## **Addendum 1**

### **Alaska Veterans & Pioneer Home Partial Re-roof ANC 17-01C**

ADDENDUM #1 7/29/2016

PHASE  
BID DOCUMENTS  
DATE  
MAY 20, 2016  
DRAWING TITLE  
ROOF PLANS-  
FIREWEED HALL

**1 EXISTING ROOF PLAN - FIREWEED HALL**  
SCALE 1/8" = 1'-0"

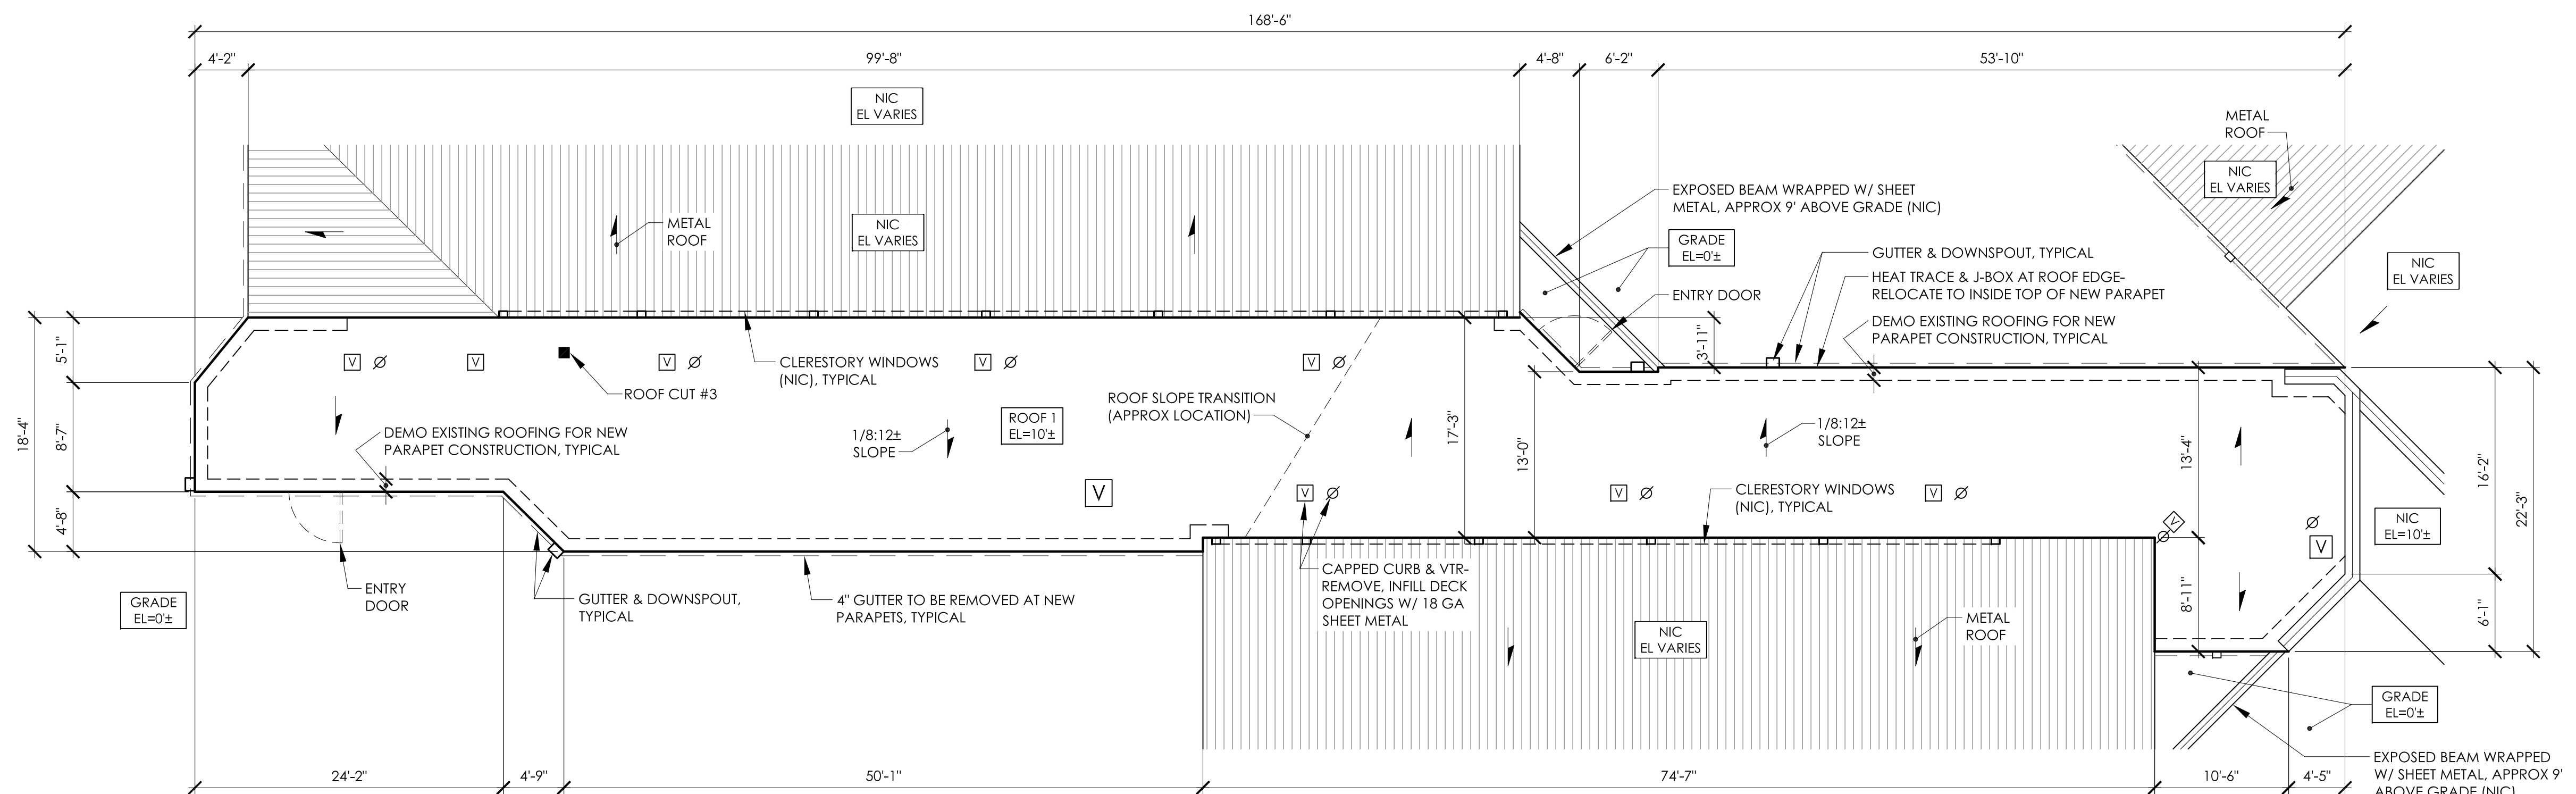
**NOTE**  
1. ELECTRICAL CONDUITS & J-BOXES TO BE REMOVED FOR NEW WORK, AND REINSTALLED ON INSIDE FACE OF NEW PARAPET. PRE-BID SITE VISIT TO QUANTIFY THIS WORK IS HIGHLY RECOMMENDED.
